Voice for Walcha's Group Submission to the Winterbourne Wind EIS

Voice for
Walcha

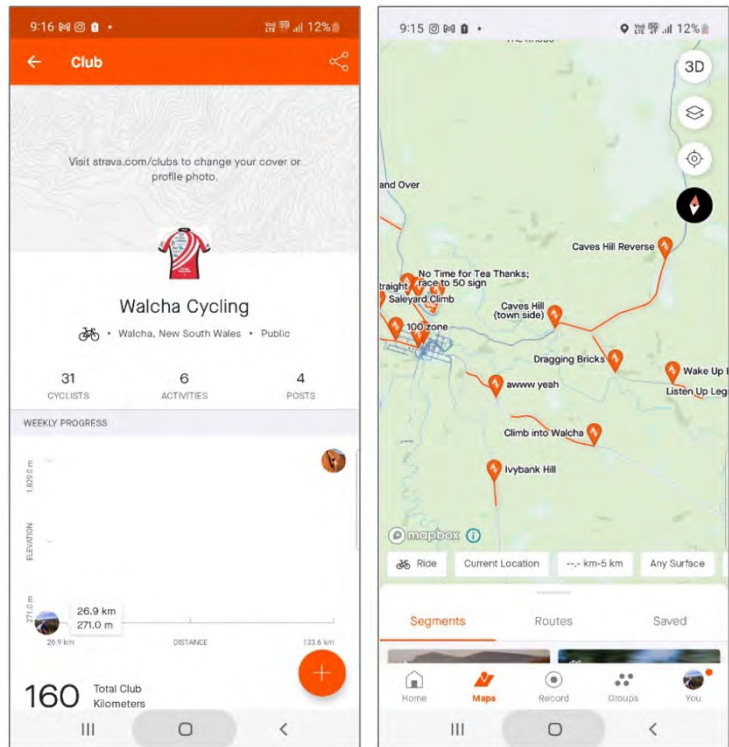
This intersection analysis is not appropriate to assess the traffic impacts east of Walcha.

Impact on Safety - The RTA Guide to Traffic Generating Development (as recommended by Transport NSW) recommends that “Where the accident history of a proposed transport route is presented, accident details (such as the type of conflict and vehicle involved) must be provided. Accident numbers alone are not sufficient for safety appraisal.”

Figure 2 Slope Analysis across the project

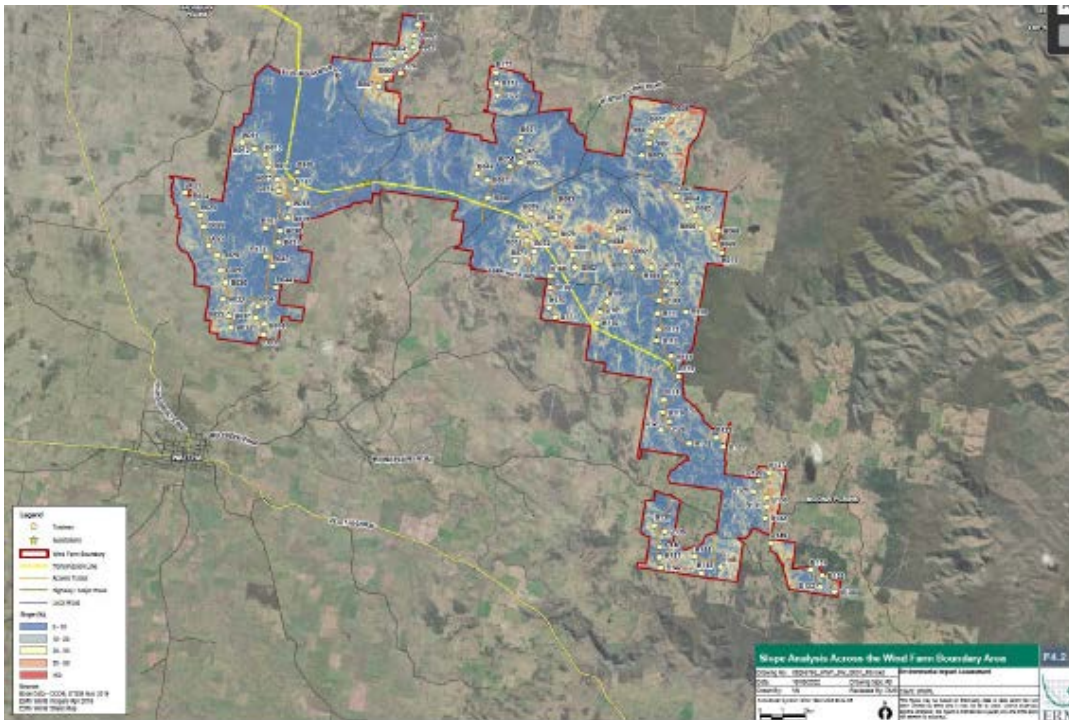
Slope analysis is shown on page 26 of Appendix P, F4.2. On this chart, it is shown that the majority of the Project Area is shaded blue, indicating a slope of <10%. However, it is clear to see the area where the bulk of the turbines and the roads will be constructed, that the slope is greater than 10%.

While most of the Project Area is blue (<10% slope), by contrast, the area under most of the turbines is grey/blue, or yellow, indicating slopes of 10-20%, or 20-33%. For some turbines, and roads connecting them, they are clearly on areas shaded orange, indicating slope of 33%-50%.
